CITY OF ALBUQUERQUE

RE: **Jefferson Mid. School Phase 1 Music Room Addition**
712 Girard SE
Grading and Drainage Plan
Engineer's Stamp Date 8-22-2015 (J16D007)

Based upon the information provided in your submittal received 8/27/15, this plan dated 8/22/15 will now be the acceptable plan for Grading Permit and Building Permit.

1-CG101

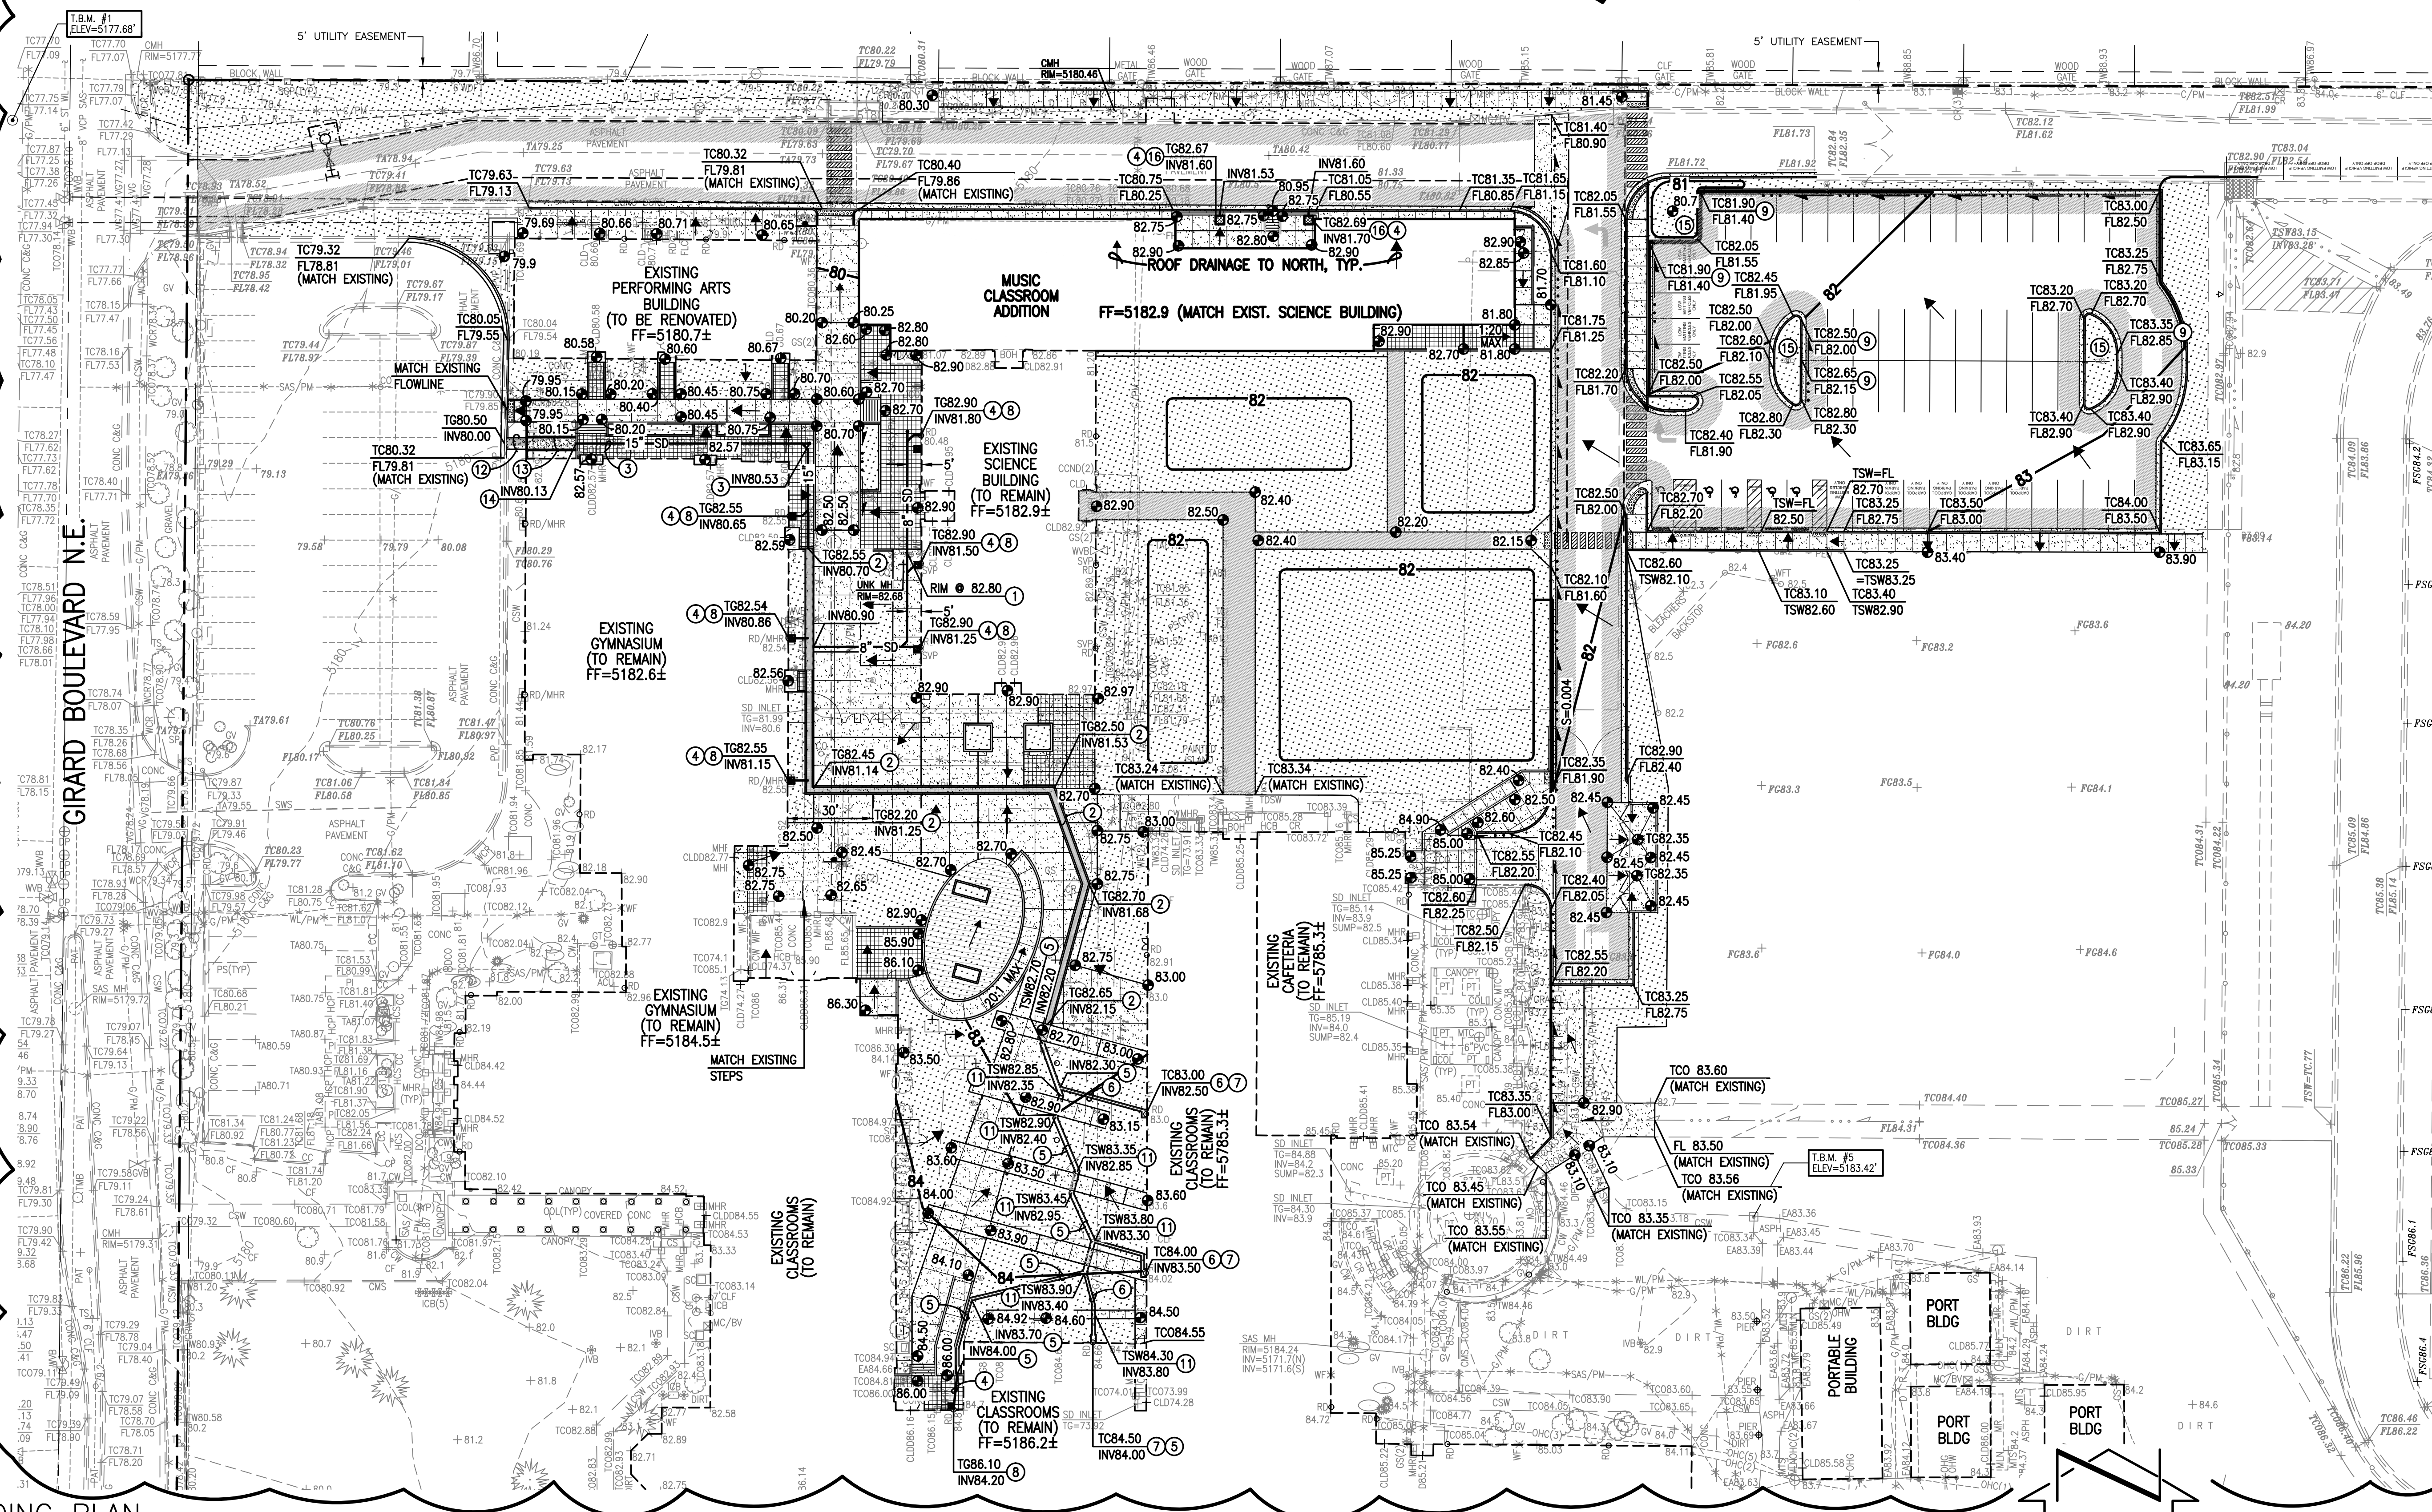
Please attach a copy of this approved plan to the construction sets in the permitting process prior to sign-off by Hydrology.

Prior to Certificate of Occupancy release, Engineer Certification per the DPM checklist will be required.
